**IMO\_REP\_0028**

### **PRELIMINARY ASSESSMENT REPORT**

**APPLICANT:** Waterloo North Hydro Inc.

**PROJECT:** New 230-28 kV Transformer Station (MTS #3)

**FIGURE 1**

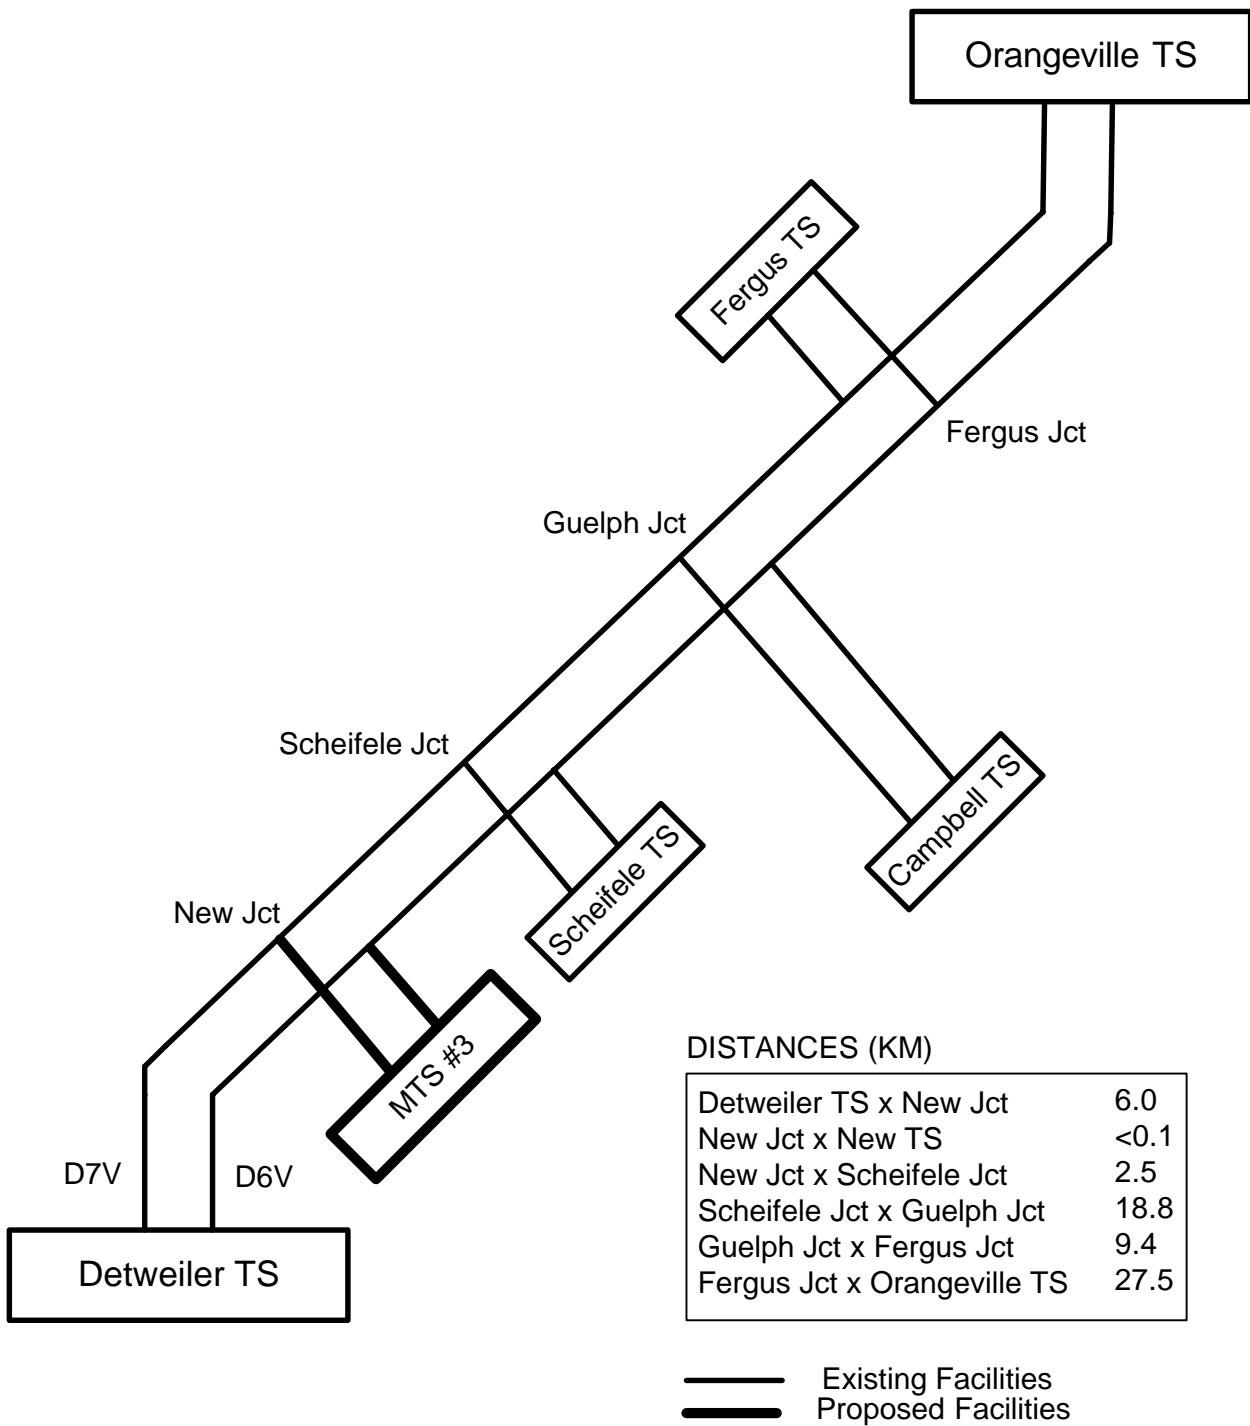
The proposed new MTS #3 will be supplied at 230 kV via the existing Hydro One Detweiler TS x Orangeville TS 230 kV circuits D6V and D7V, as shown in Figure 1. These circuits also supply Scheifele TS, Guelph Campbell TS and Fergus TS.

**FIGURE 2**  
**Detweiler TS 230kV Voltage Measured in Year 2000**

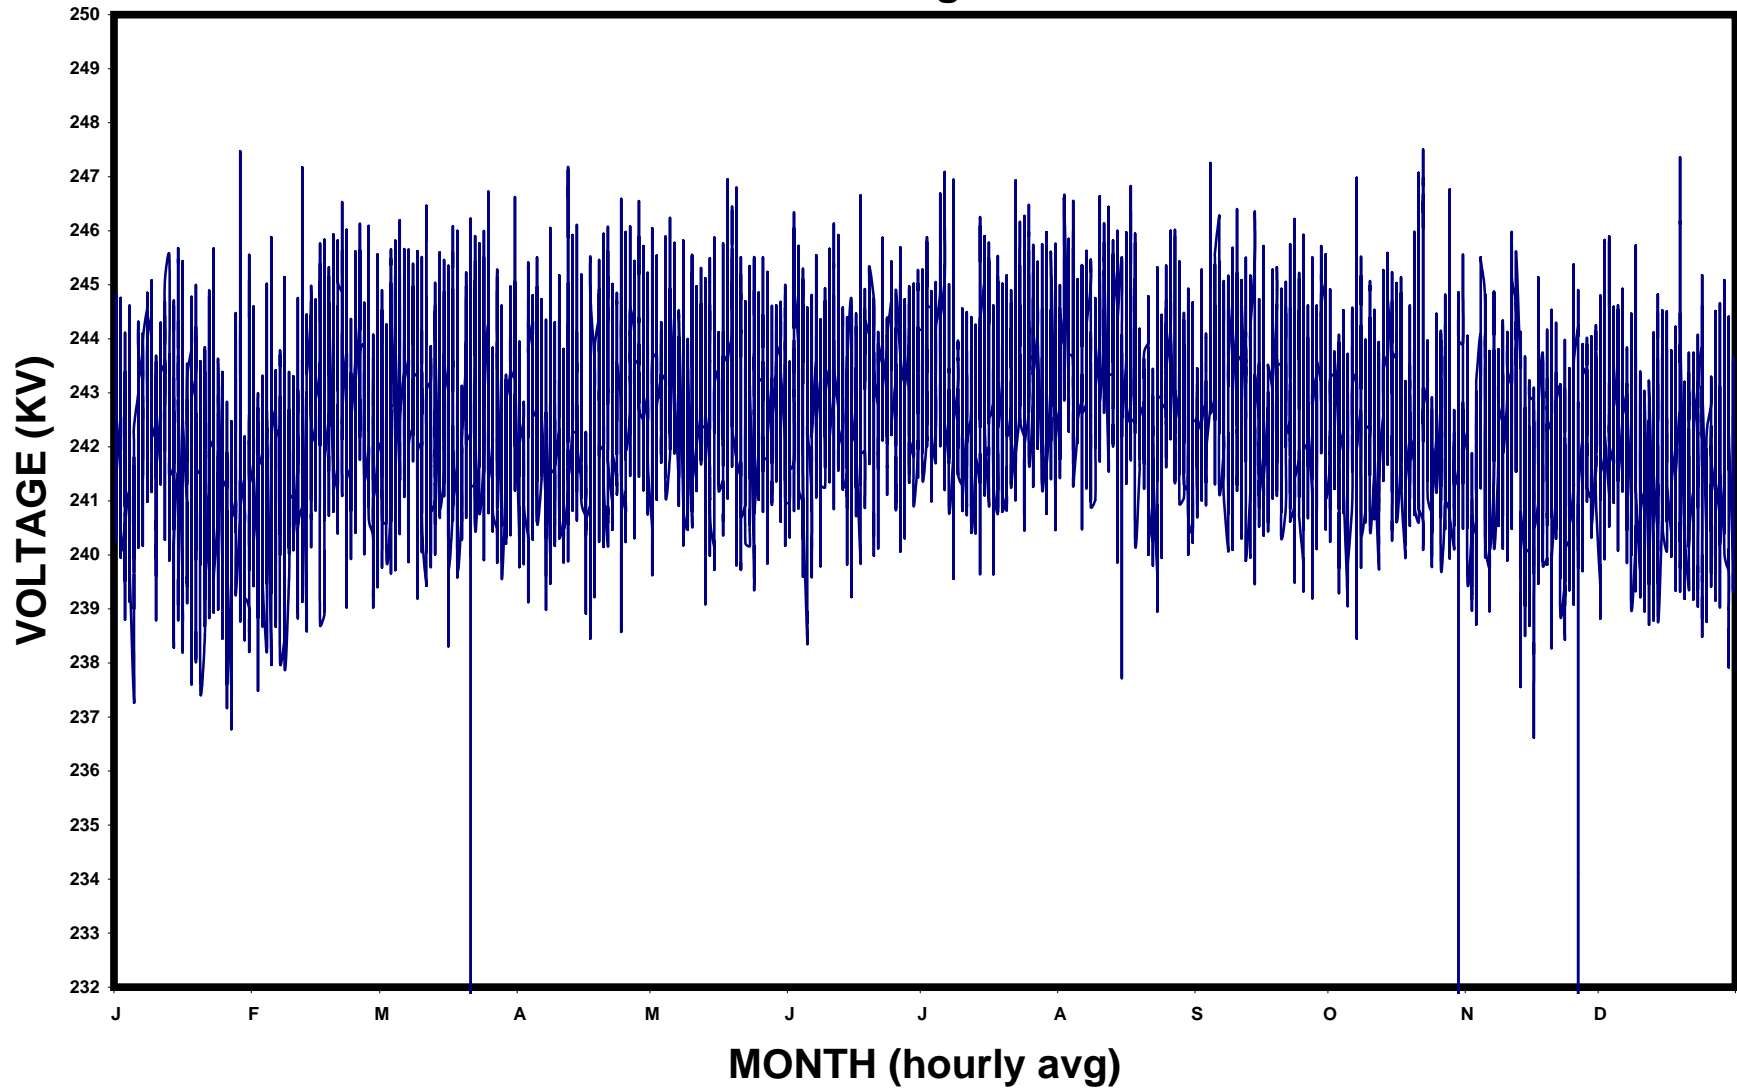
Figure 2 shows the actual measured voltage at Detweiler TS 230 kV bus during the year 2000. The voltage at the location of the proposed new WN MTS #3 is expected to be approximately 1 kV below the level at Detweiler TS.
